CITY OF CODY
PLANNING, ZONING AND ADJUSTMENT BOARD
TUESDAY, AUGUST 28, 2012
CITY HALL COUNCIL CHAMBERS @ 12:00 NOON

**CITY OF CODY
PLANNING, ZONING AND ADJUSTMENT BOARD
STAFF REPORT**

MEETING DATE:	AUGUST 28, 2012	TYPE OF ACTION NEEDED	
AGENDA ITEM:		P&Z BOARD APPROVAL:	X
SUBJECT:	REVIEW PROPOSED 16-LOT SUBDIVISION KNOWN AS COOPER LANE ESTATES (GLENN & NINA ROSS) SUB 2012-	RECOMMENDATION TO COUNCIL:	
PREPARED BY:	TODD STOWELL, CITY PLANNER	DISCUSSION ONLY:

**AMENDED FINAL PLAT
 OF
 BLACKBURN P.U.D.**

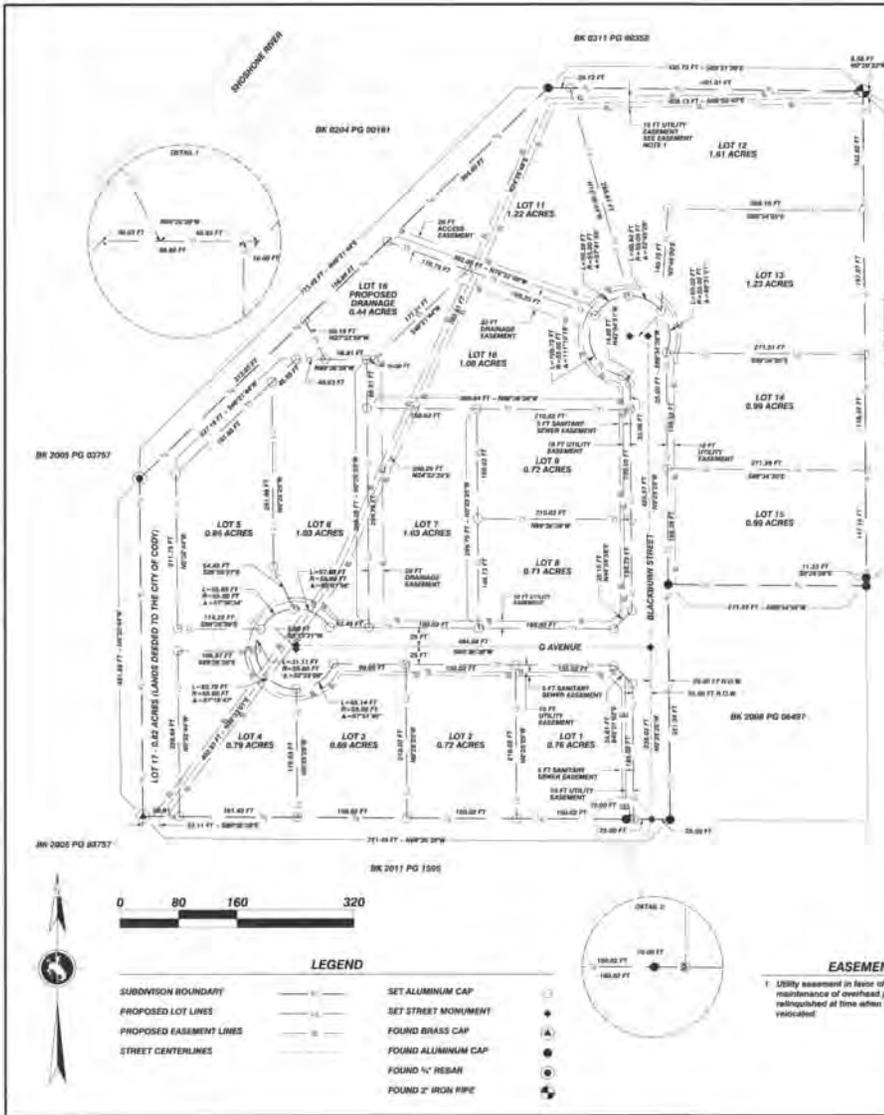
Removal of the power line that crossed the property in a north-south direction has occurred, but the line along the north end of the property remains—it serves a property to the north. The surveyor needs to show the remaining section of power line and the approximate location of the underground service running to the property to the north. It is also recommended that proper descriptions of the situation be noted on the final amended plat, such as labels for the “Existing power line serving property to north” and “Approximate location of underground service line”.

It is also recommended that an additional note be required on the plat describing the private pressurized sewer system in more detail than exists in Note 12. The following language is recommended:

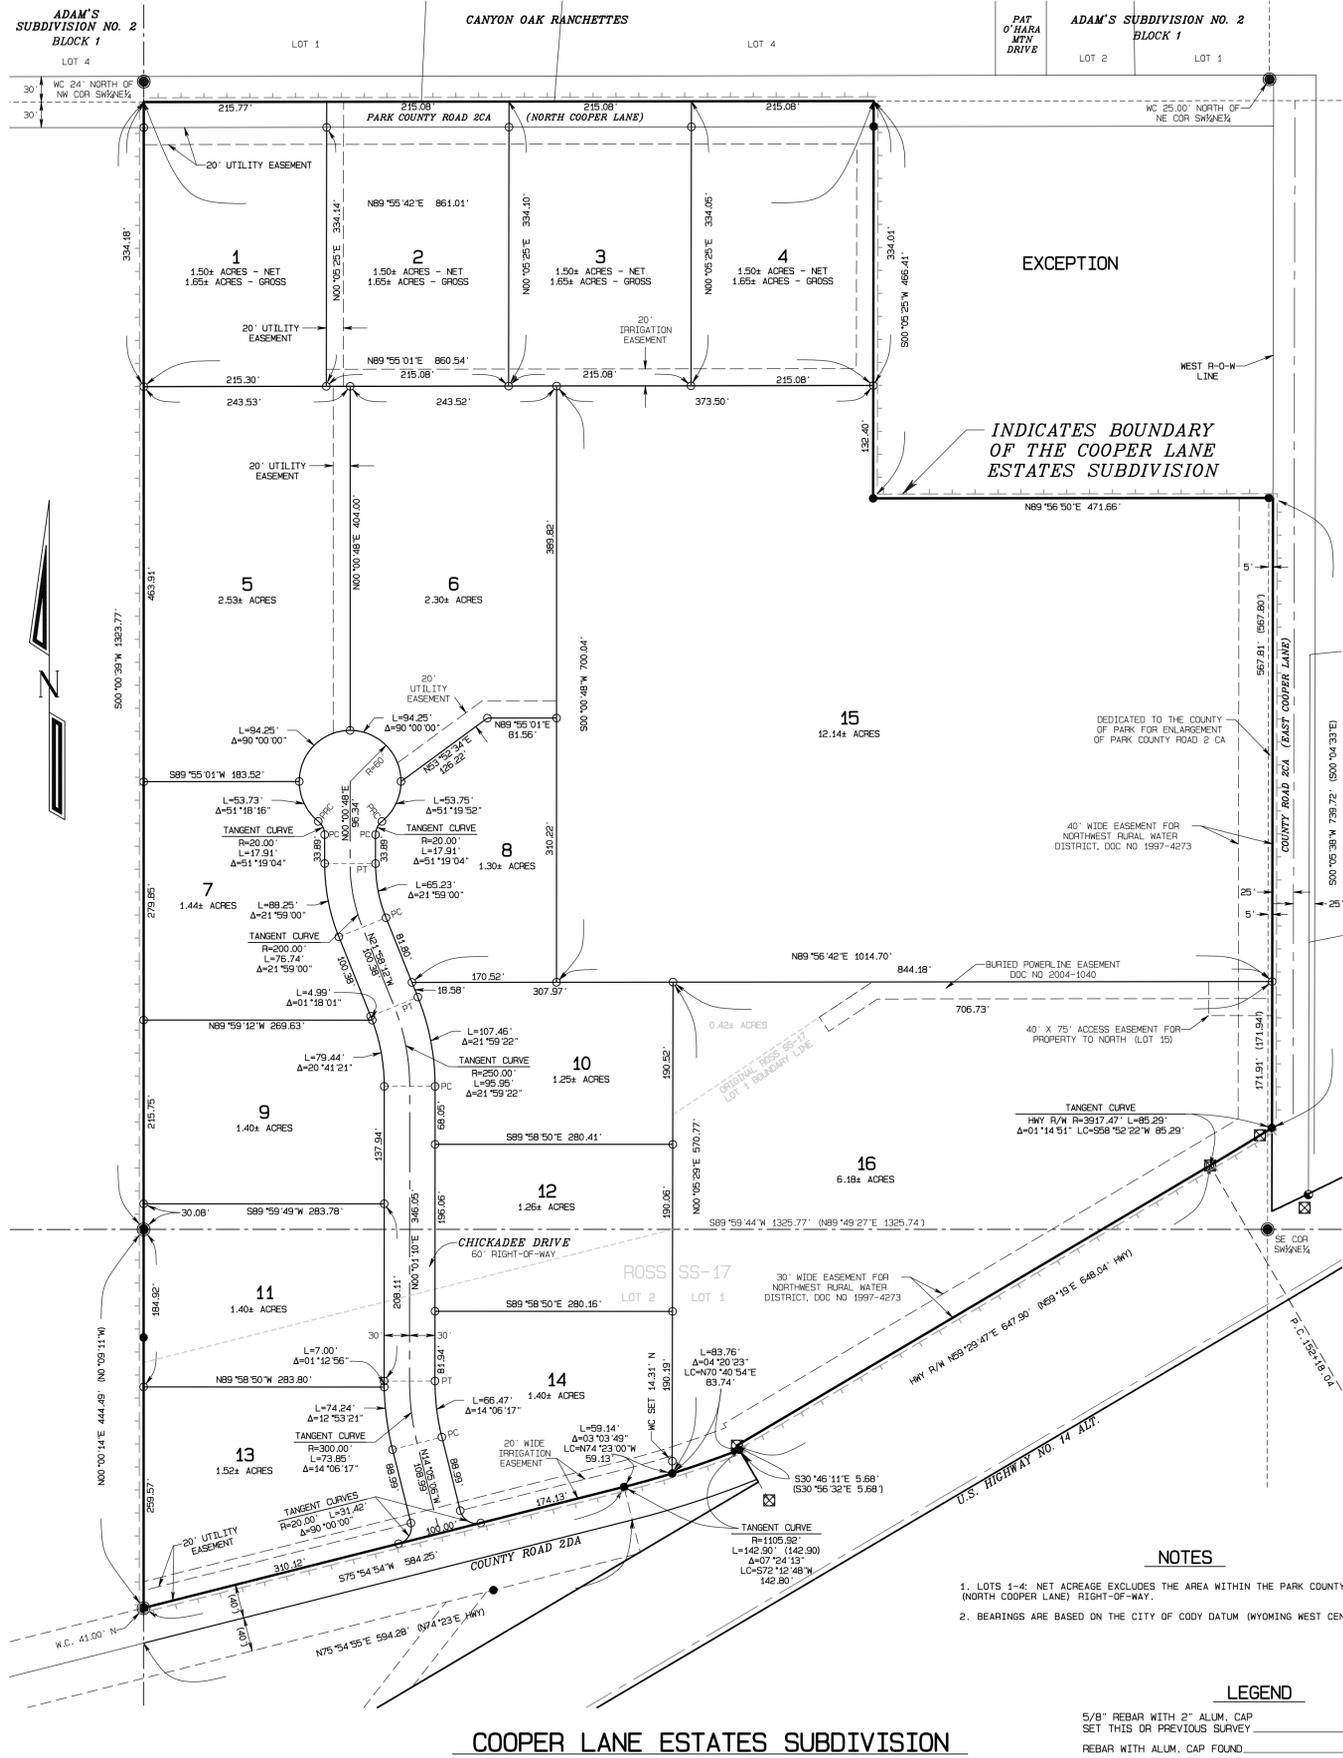
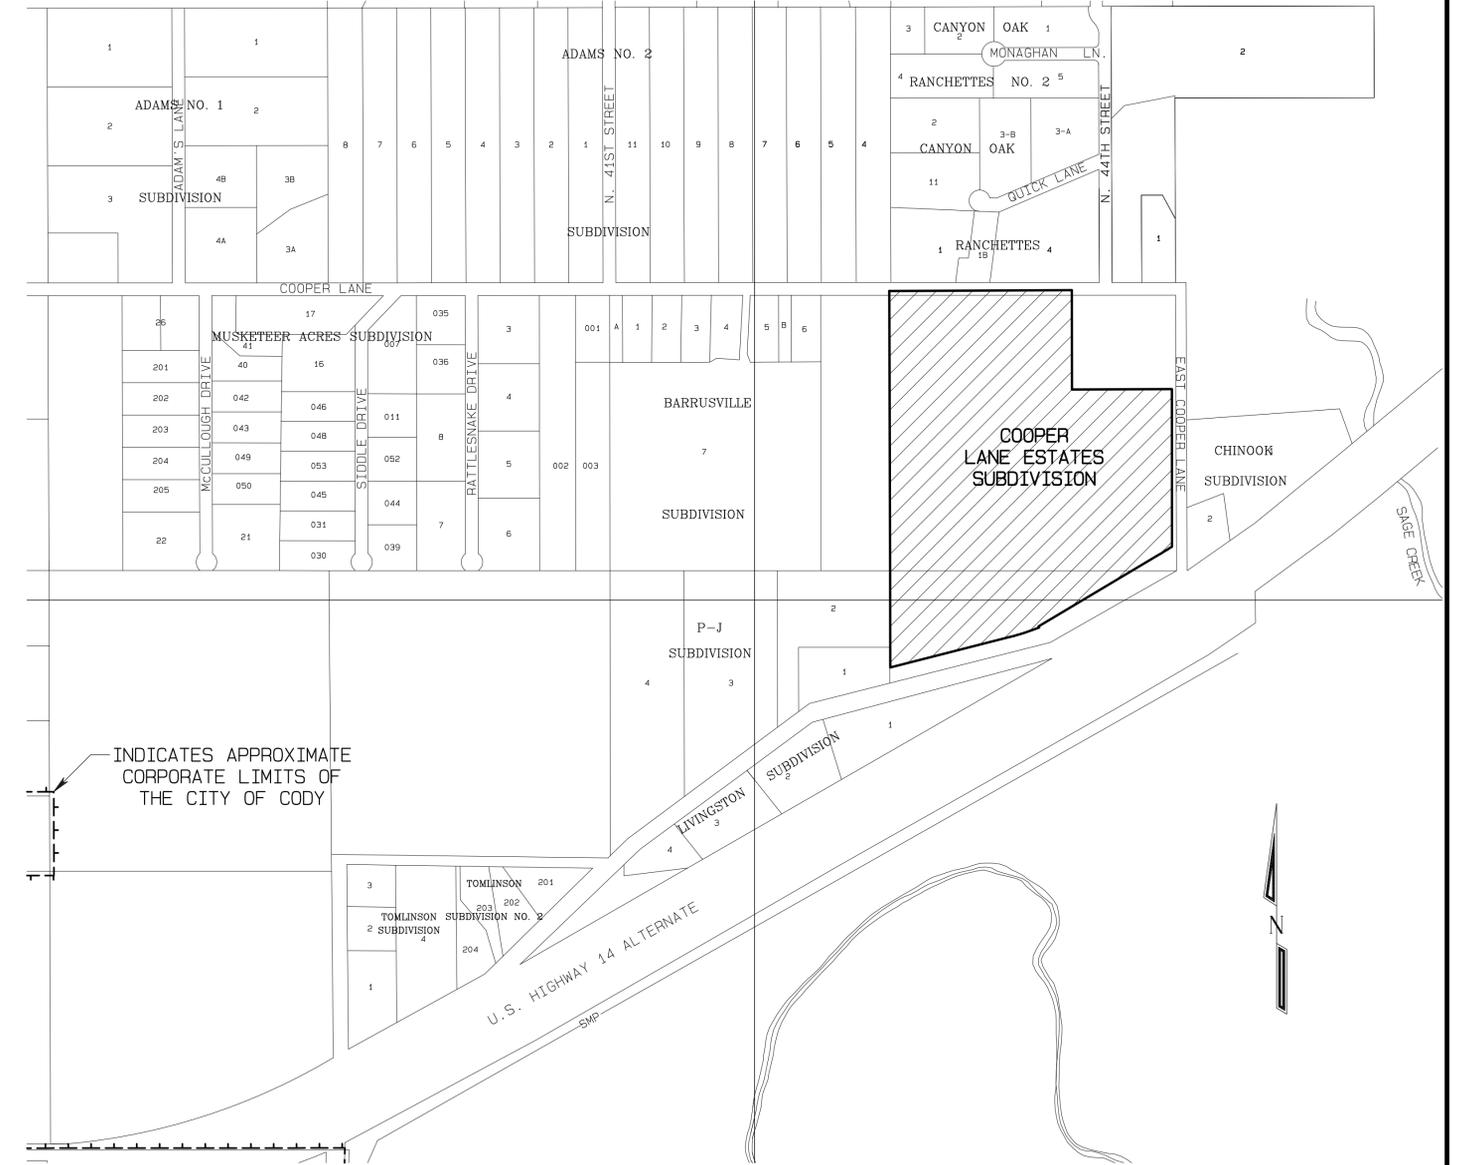
Staff Comment- The proposal does not include any street extensions or intersections that need to align with existing streets.

Staff Comment- A variance from this standard would be necessary to permit the proposed subdivision configuration. The master street plan indicates two north-south local streets and one east-west local street running through the property. The applicant requests the variance from conformance with the master street plan.

Staff Comment: As proposed, the length of the cul-de-sac at 960 feet does not meet this requirement, which would require a variance.

Staff Comment: The interior residential street and existing road 2DA meet the applicable right-of-way standards. The existing right-of-way width on Cooper Lane is 60 feet, where 80 feet is the City standard. A 20-foot utility easement is proposed along Cooper Lane. A variance would be needed for the proposed configuration.

Staff Comment: A 6" main line will be required, and the main line will be required to be "looped", so that there is not a 900'+ dead-end line. Water is to be provided by Northwest Rural Water.

Staff Comment: The irrigation plan needs more detail. Based on the original application, existing private ditches through the property will be eliminated. The irrigation ditches along Cooper Lane and Road 2DA have not been discussed.
